| Document Title: | NRDC Comments on Pool Pump and Spas Draft Staff Report |

Analysis of Efficiency Standards for Pool Pumps and Motors, and Spas

2015 Appliance Efficiency Rulemaking Docket Number 15-AAER-02

Figure 1: Portable Electric Spas in the CEC Modernized Appliance Efficiency Database System (MAEDBS)²

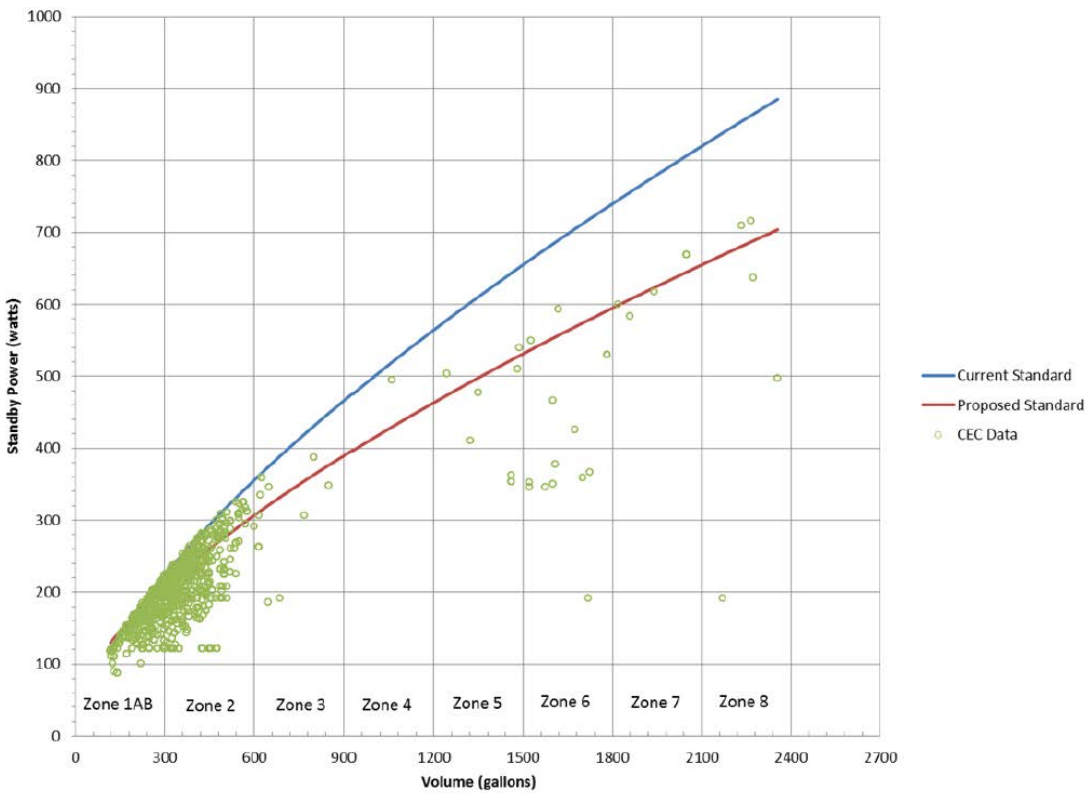
As can be seen from Figure 1, there is a wide range of standby energy use for any given spa capacity, indicating significant potential energy savings from updated standards and labeling. The updated standards proposed by the CEC are cost-effective and technically feasible: spas at the full range of capacities meet the proposed standards today and the CEC estimates that the proposed standard will have a life-cycle benefit to cost ratio of 5-to-1 for portable electric spas.³ The proposal to require spas to be labeled will achieve additional energy savings by providing consumers information about how much energy a spa consumes. There is a wide range of efficiency amongst spas that meet the proposed standard: standby energy can vary by over 50 percent for a spa of the same capacity. Given this range of efficiency, providing consumers with information about the energy use of spas will allow them to compare models and purchase spas that are more efficient than the minimum standard.
